VANDEWALLE & ASSOCIATES INC.

Re: Review of the proposed rezoning of 2801 Marshall Court: “Lodgic”
From: Medical Office-Commercial (C-3)
To: Planned Unit Development (PUD): General Development Plan (GDP) and
Specific Development Plan (SDP)

PLANNERS' PROJECT REVIEW

1 SITE PLAN
C-1.1
1" = 20'-0"

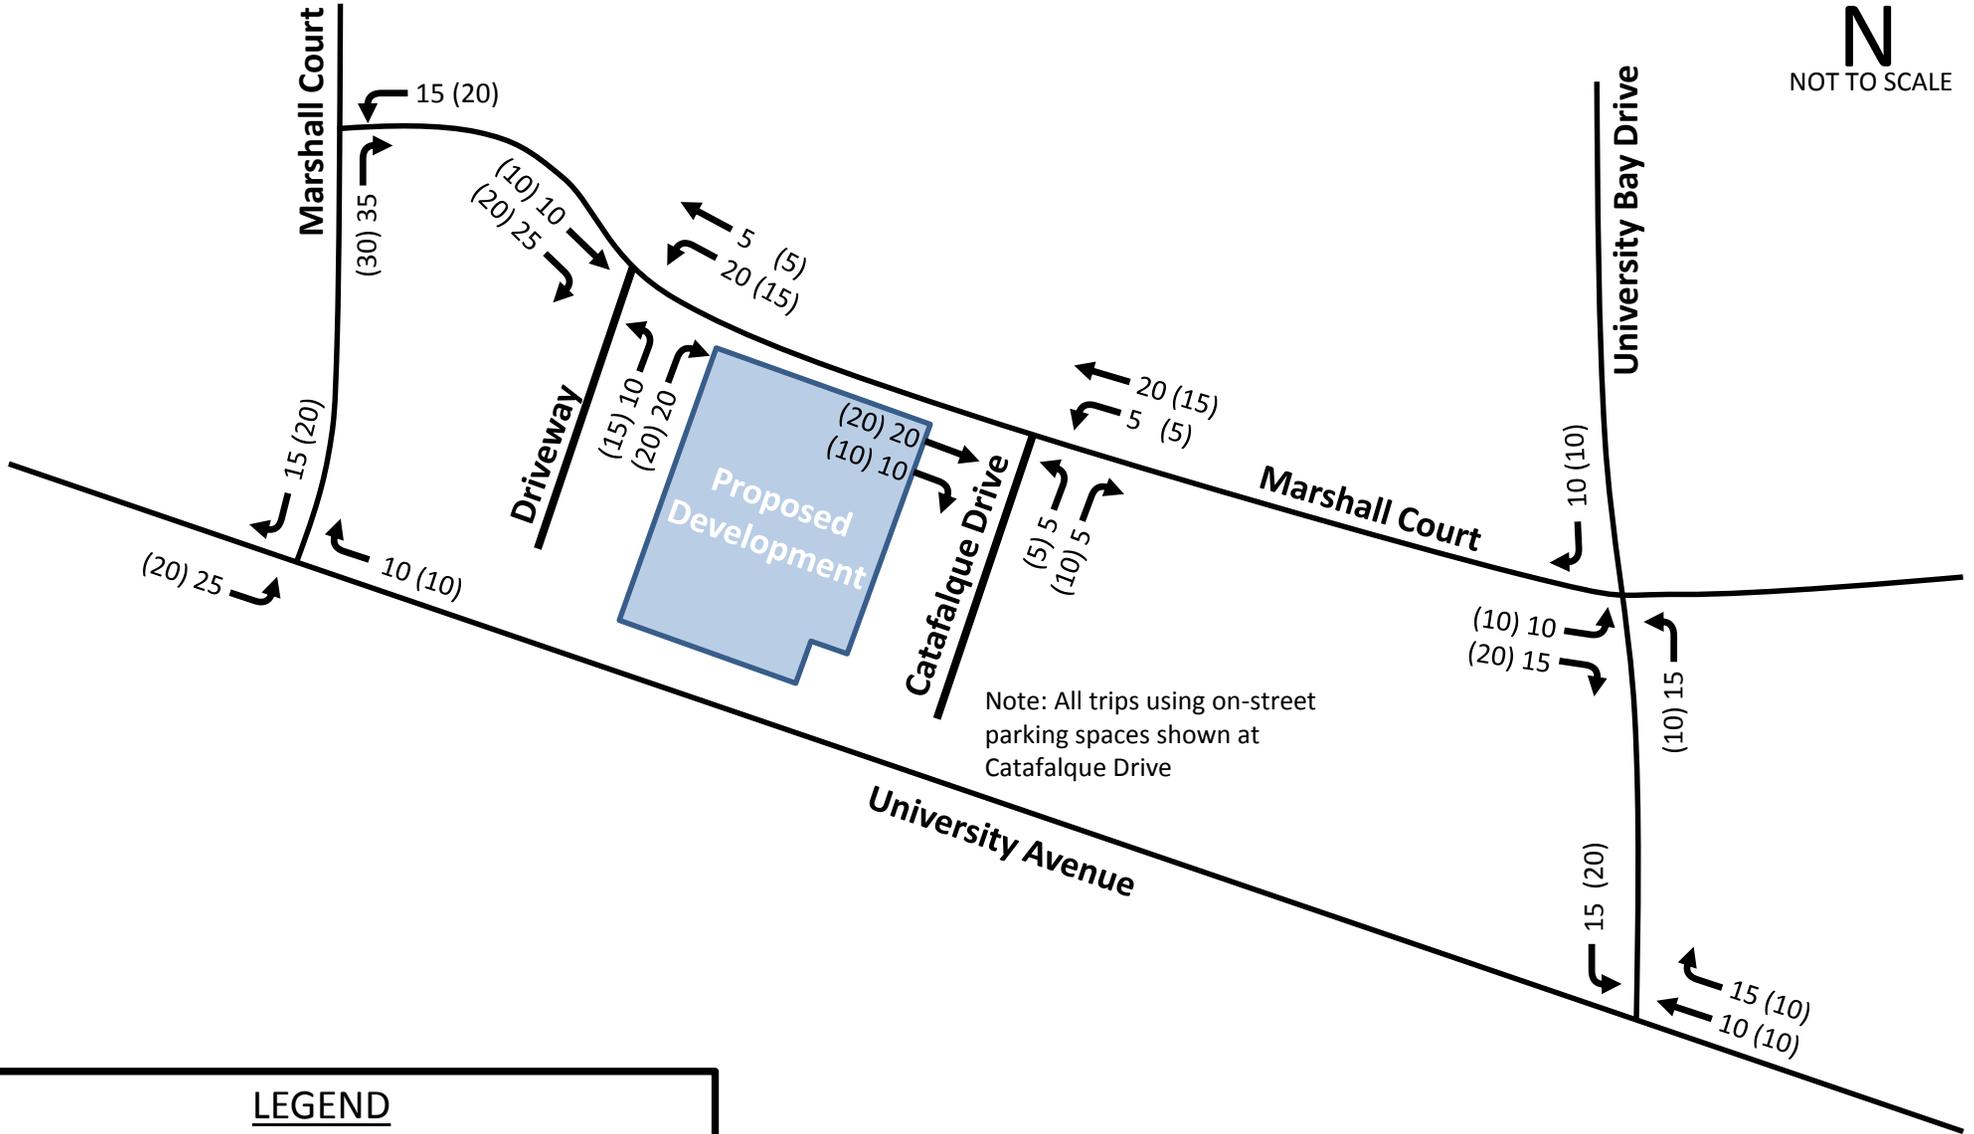
- Sheet C-1.1: Site Plan for the subject property depicting its proposed relationship to neighboring roads, the public pedestrian/bike path, parking spaces, and buildings. Note the proposed driveway from Marshall Court to the underground parking area is located along the west side of the building and is partially-covered by a roof terrace over the south half of the driveway. The proposed 1,275 square foot outdoor play area for the daycare center is located along the south edge of the building. The main building entrance for the restaurant and event space is located along the Marshall Court sidewalk near the west corner of the building, while the main building entrance for the daycare and elevator lobby is located along the Marshall Court sidewalk near the east corner of the building.
